## REVISED Certificate of Appropriateness Case Report

*Filing Date:* December 2, 2010  
*Case No.:* **2010.1072A**  
*Project Address:* **937 VALENCIA STREET**  
*Historic Landmark:* Liberty-Hill Historic District  
*Zoning:* Valencia Street Neighborhood Commercial District  
50-X Height and Bulk District  
*Block/Lot:* 3609/036  
*Applicant:* Jane Martin  
Shift Design Studio  
2717 Harrison Street  
San Francisco, CA 94110  
*Staff Contact* Richard Sucre - (415) 575-9108  
richard.sucre@sfgov.org  
*Reviewed By* Timothy Frye - (415) 575-6822  
tim.frye@sfgov.org

**DATE:** April 6, 2011  
**TO:** Architectural Review Committee of the Historic Preservation Commission  
**FROM:** Rich Sucre, Historic Preservation Technical Specialist, (415) 575-9108  
**RE:** **Review and Comment for 937 Valencia Street**  
**Case No. 2010.1072A**

SIDE ENTRY GATE

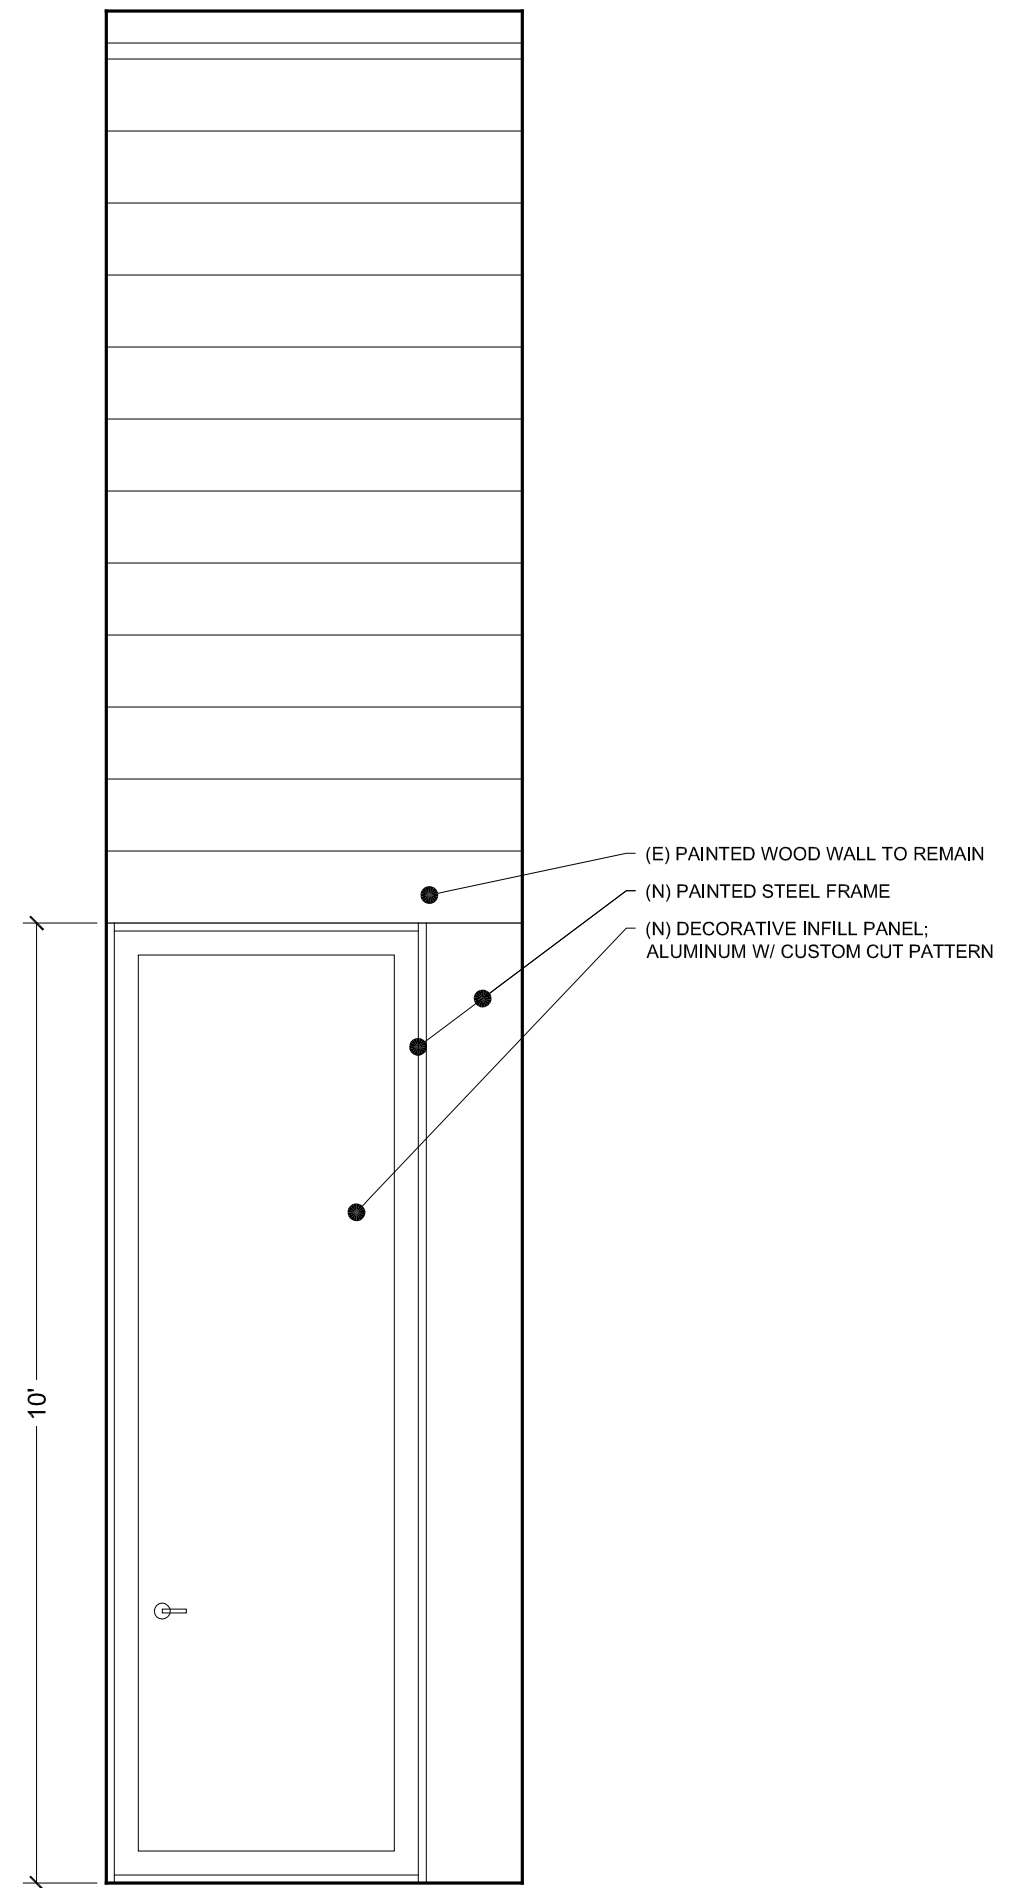
As part of the removal/reconfiguration of the secondary stair, a new side entry door/gate will be constructed at the ground floor level. This new side entry door is designed as a new decorative aluminum infill panel set within a steel frame. This infill panel will feature a custom cut floral/vegetal pattern and will be constructed of 3/16" aluminum.

Although aluminum entry doors are not common in the historic district, the Department determined that this type of door would not detract from the overall character of the historic district, as long as it remains secondary to the main entry and is not visually prominent.

The HPC had varying comments regarding the side entry door/gate. One Commissioner commented that the proposed design was acceptable and compatible, while another Commissioner did not find the cut-out aluminum panel to be compatible with the character of the historic district.

The Department recommends simplifying the side entry door to match other examples found within the historic district. Specifically, the side entry door should either be constructed of wood or metal. If the side entry door is wood, then it should be solid in appearance and simple in design with no cut-out elements. If the side entry door is metal, then it should be open in design and function similar to a gate with narrow, vertical metal elements. All metal elements should feature a painted finish, as is common in the historic district. Based upon HPC comments, cut-out aluminum panels should not be used due to questions of their compatibility.

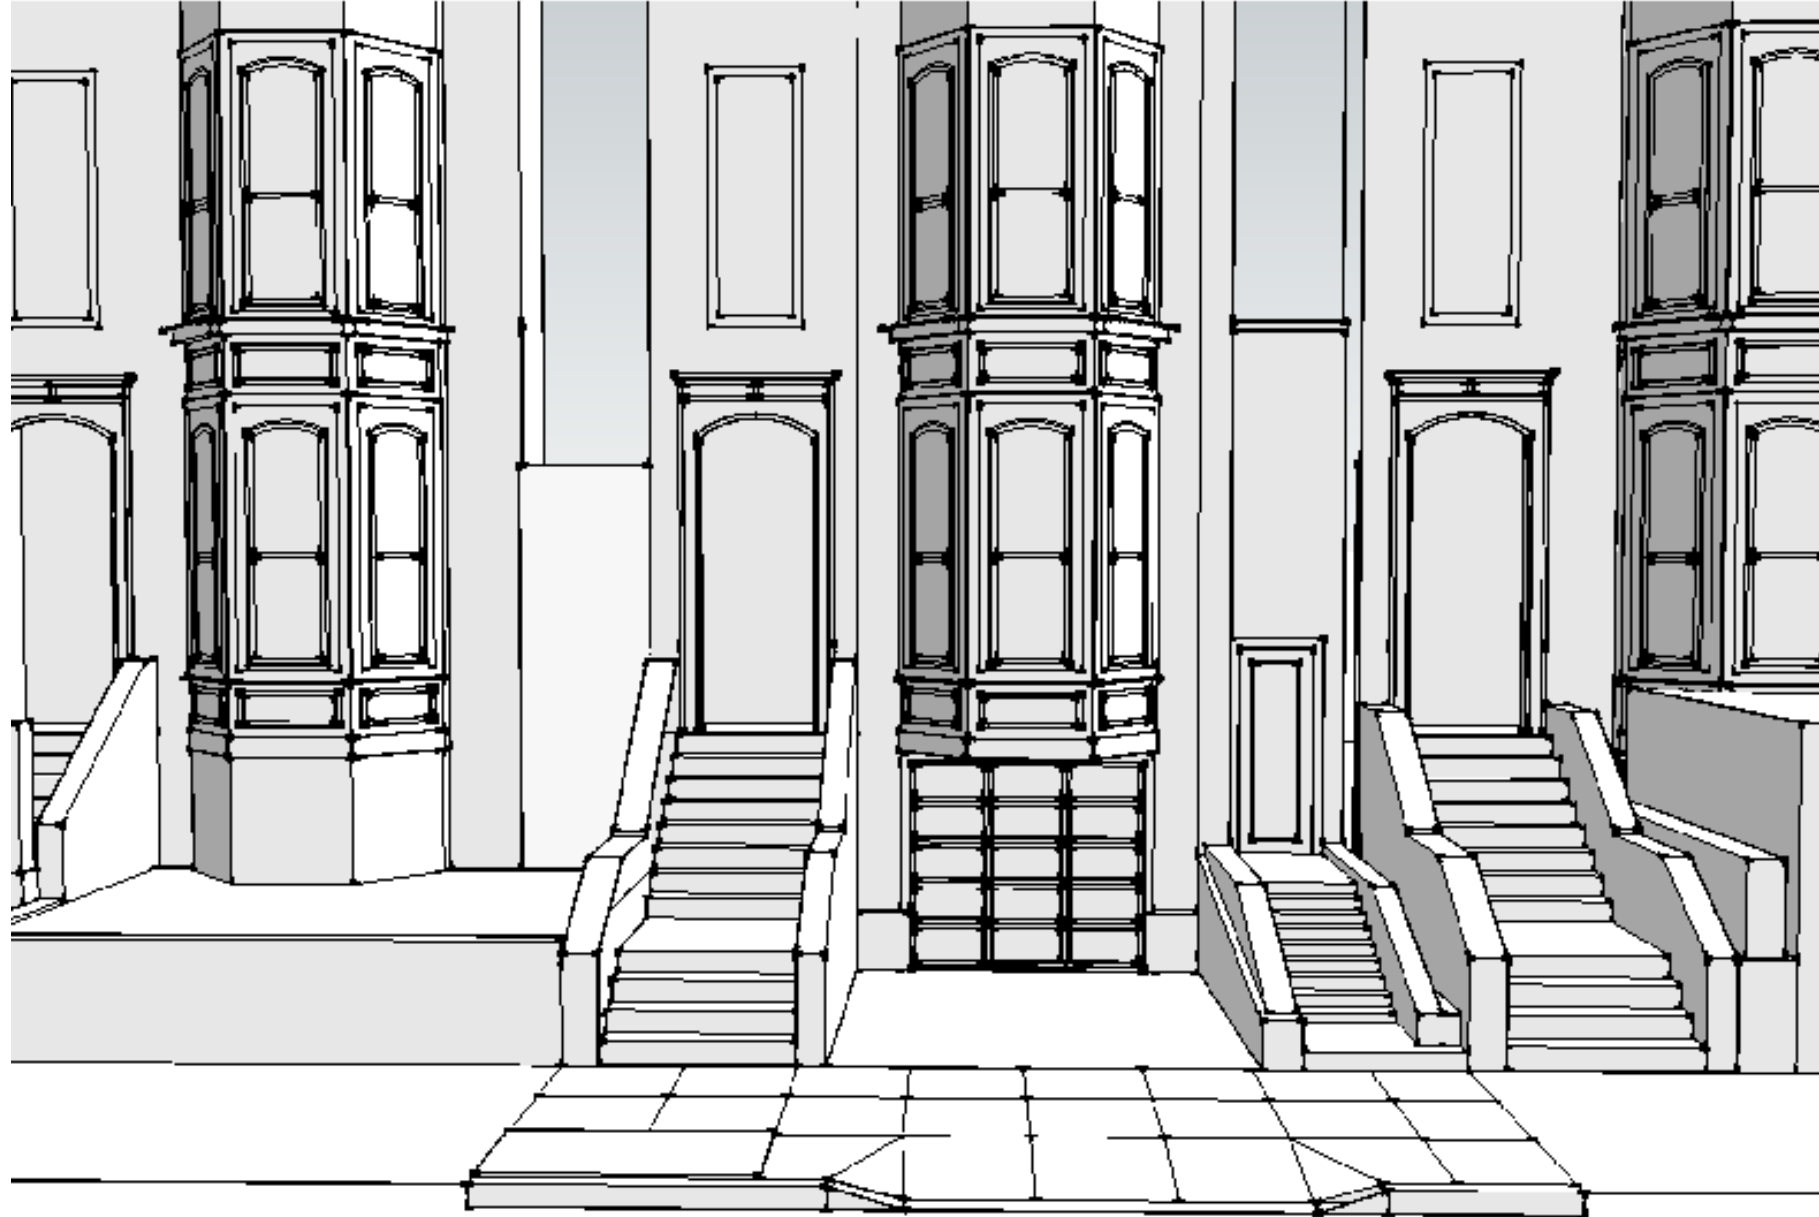
As an alternative to the proposed design, the Sponsor has submitted a variant for discussion, which shows the main entry staircase with two newel posts at the bottom of the upper staircase. This variant has not been previously reviewed by HPC. This variant does not provide information on the handrail material or treatment of the infill panels. This variant addresses the Department's earlier concerns regarding the newel posts.

The HPC determined that the proposed handrail is not compatible with the character of the historic district. Specifically, questions arose regarding the selection of steel as an appropriate handrail material that is compatible with the historic district, and the appropriateness of cut-out panels in the design of the new handrail. The HPC noted the importance of a newel post in the design of compatible staircases.

The Department recommends adopting the variant and specifying that all metal elements have a painted finish, in order to relate to the material treatment found within the historic district. The variant incorporates a newel post and also eliminates the landing shelf.
